TOWN OF ASHLAND CITY

Planning Commission Meeting

BROOKHOLLOW SENIOR
APARTMENTS
 ASHLAND CITY, TN
 CONSTRUCTION PLANS
 SCALE: 1"=60'

SUBJECT: Brookhollow Senior Apartments
Plan Revision Re-Submittal #1

PRE-DEVELOPED WATERSHED

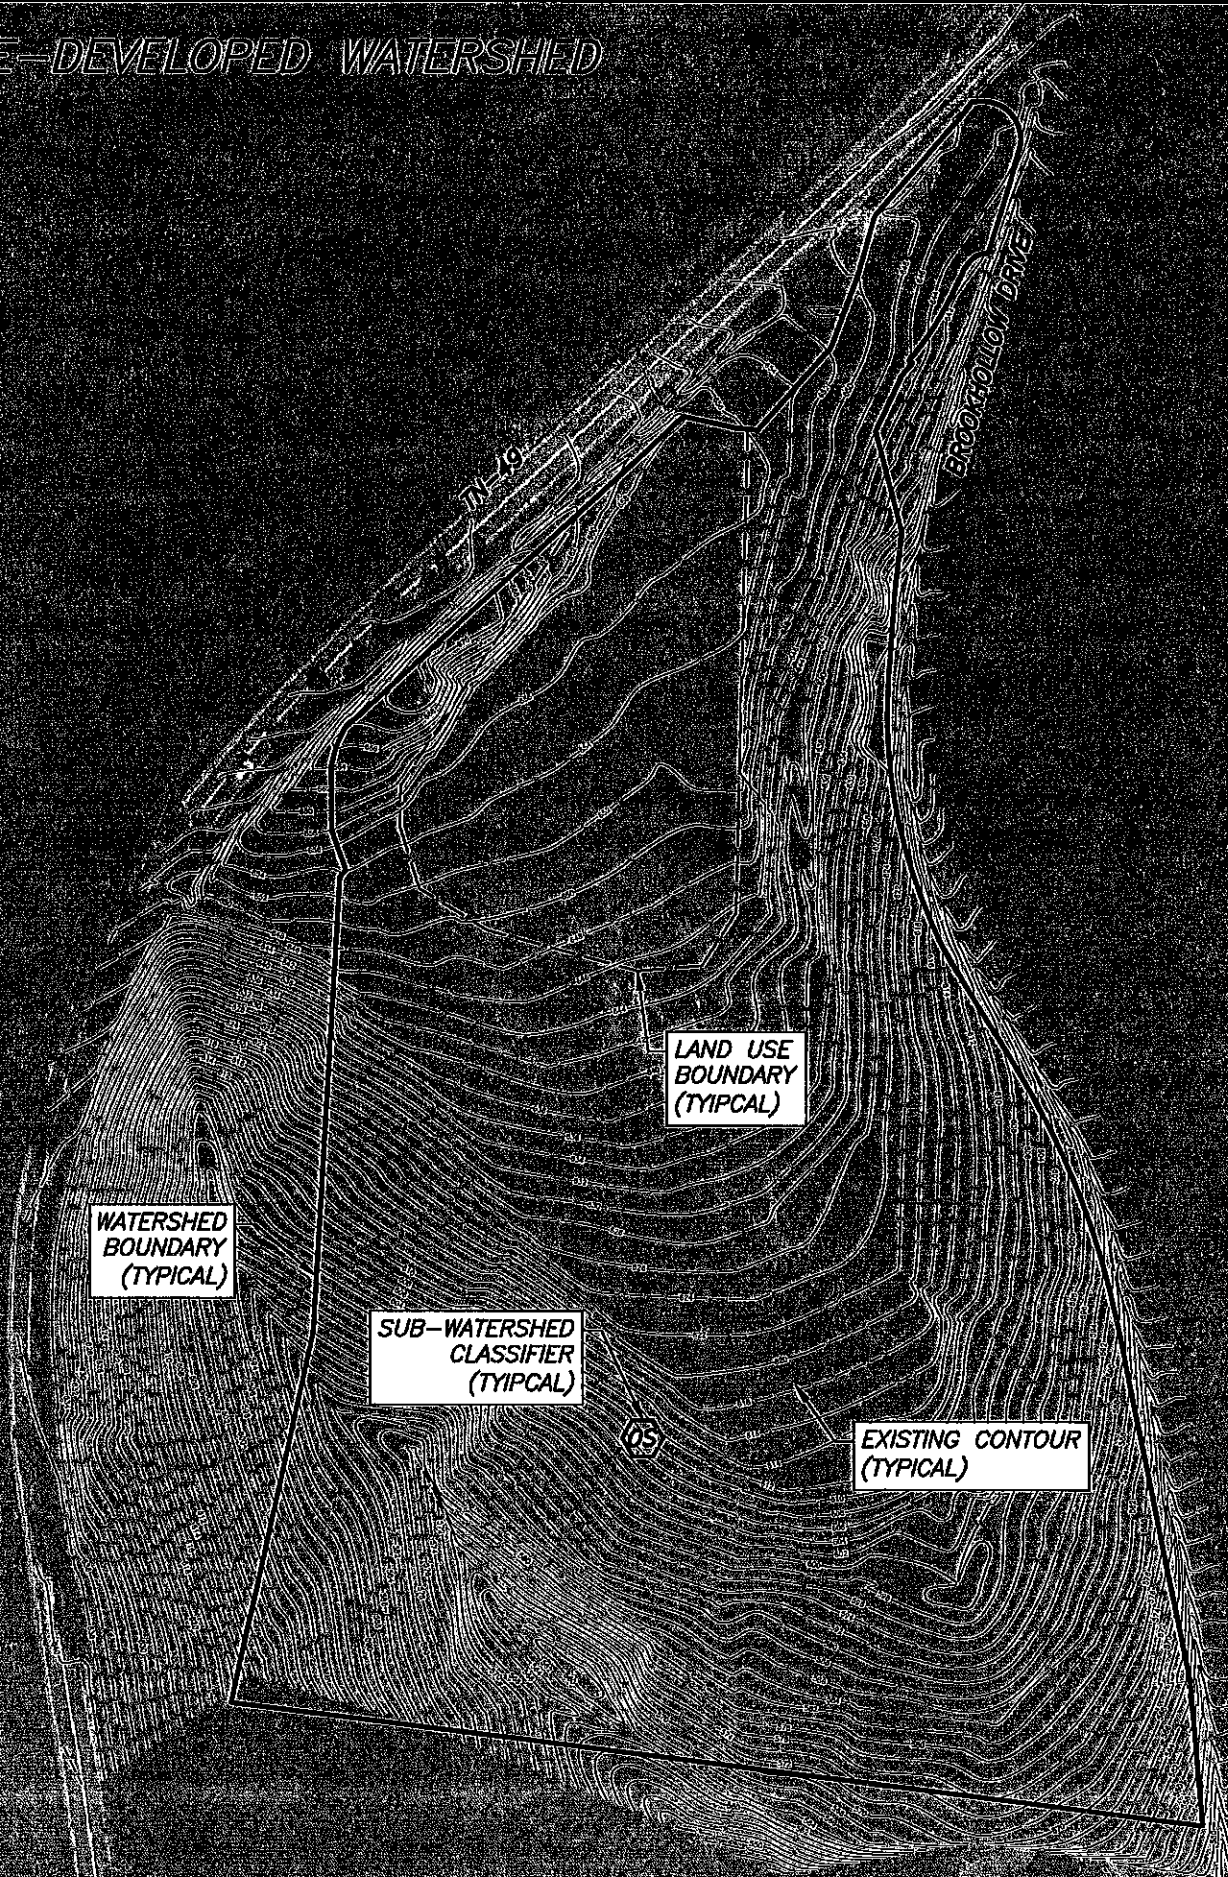
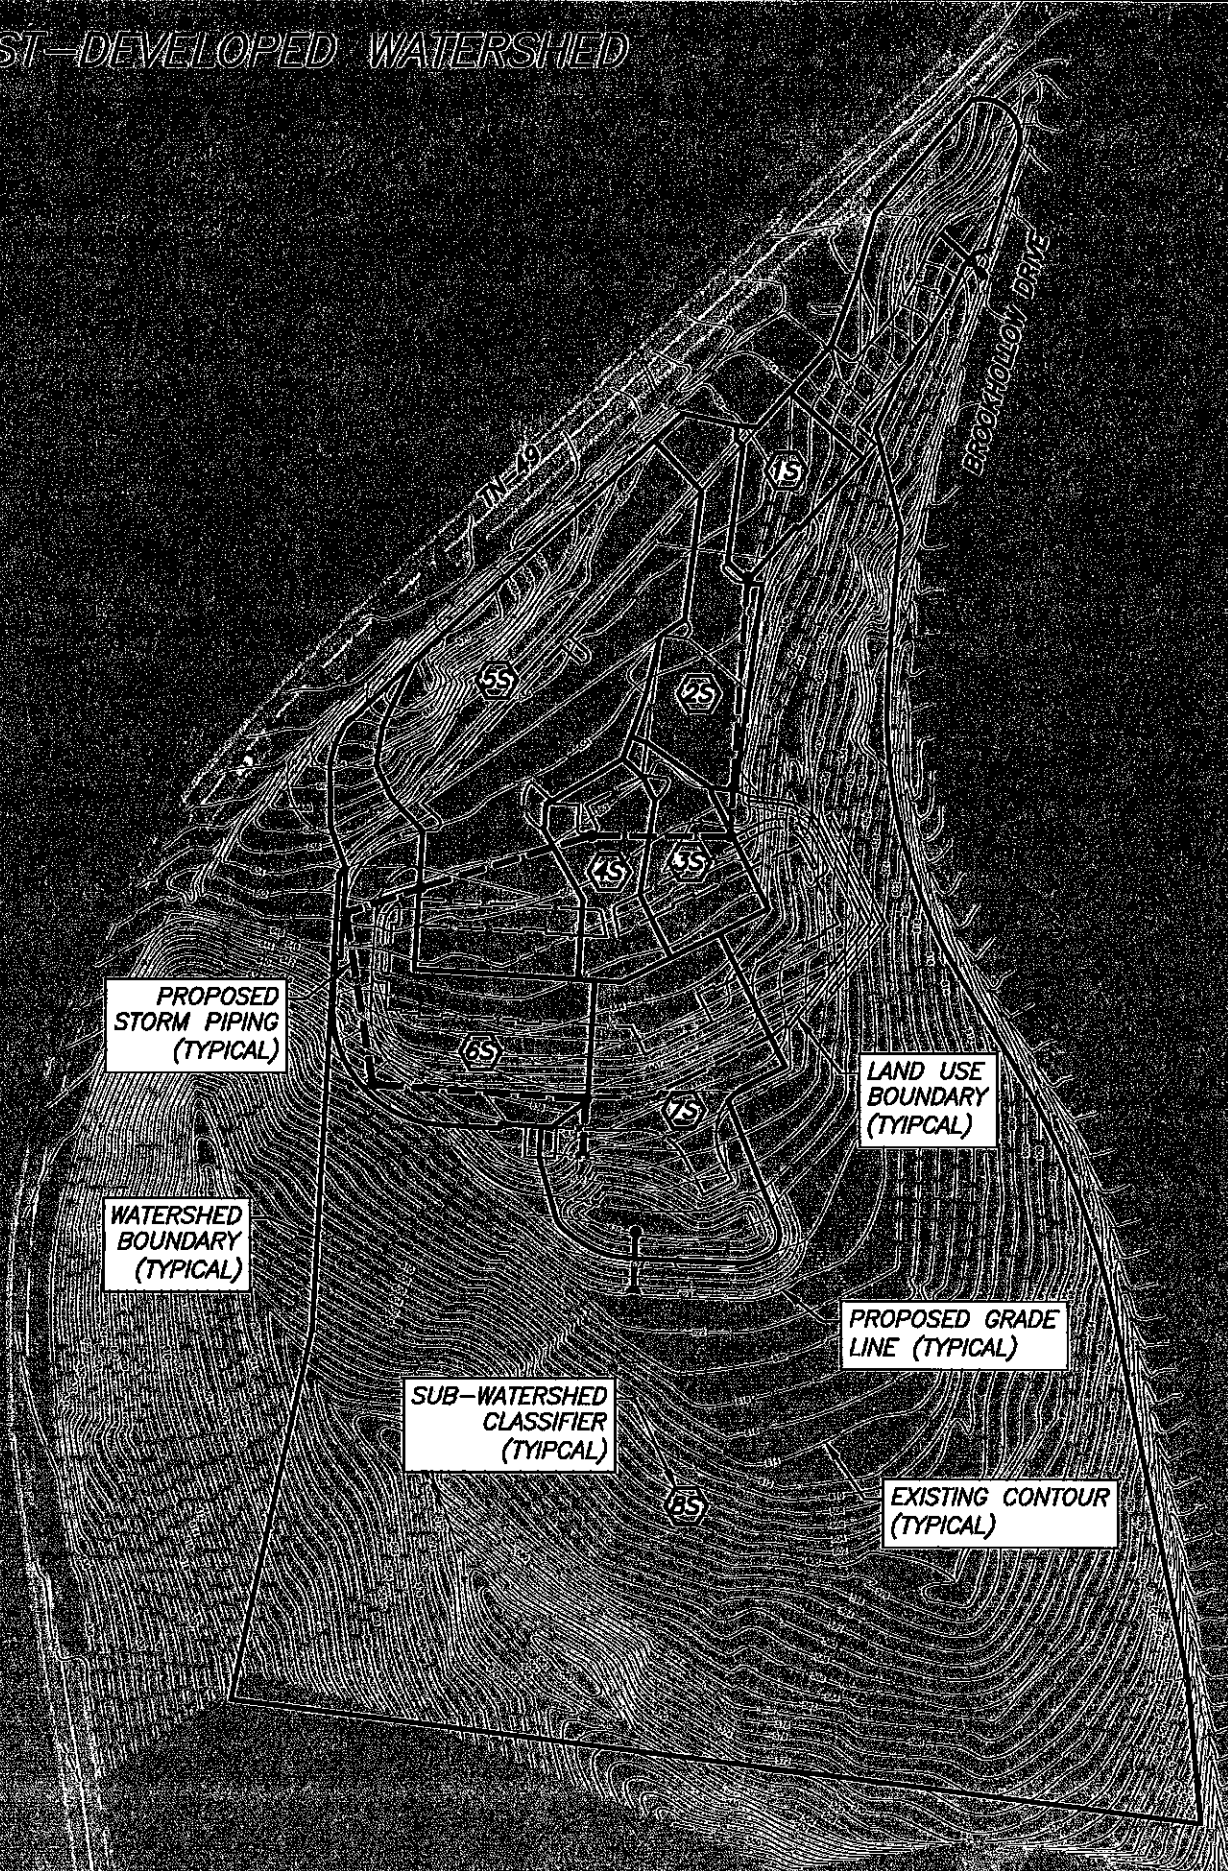
- A summary has been added, as requested which references a drainage map and the included hydrologic model containing all of the details mentioned in the revision request.
 - Drainage maps for both the pre- and post-development conditions have been added in order to simply review of the attached model and provide reference locations for required data.
- Headwater calculations for all subbasins are available in the model provided and are referenced in the hydrologic summary.

The intention of the design as it relates to stormwater runoff is to withhold post-development runoff rates to values less-than or equal-to pre-developed conditions. The following table compares the pre-developed, uncontrolled condition of runoff with the post-developed, detention-routed condition for the 2, 5, 10, 25, 50 & 100-year rain events with 24-hour durations:

Return Event (24 hr)	Pre-Developed Runoff (cfs)	Post-Developed Runoff (cfs)
2 year	8.2	8.1
5 year	13.7	11.9
10 year	18.7	17.7
25 year	26.4	23.0
50 year	33.0	29.0
100 year	40.1	37.7
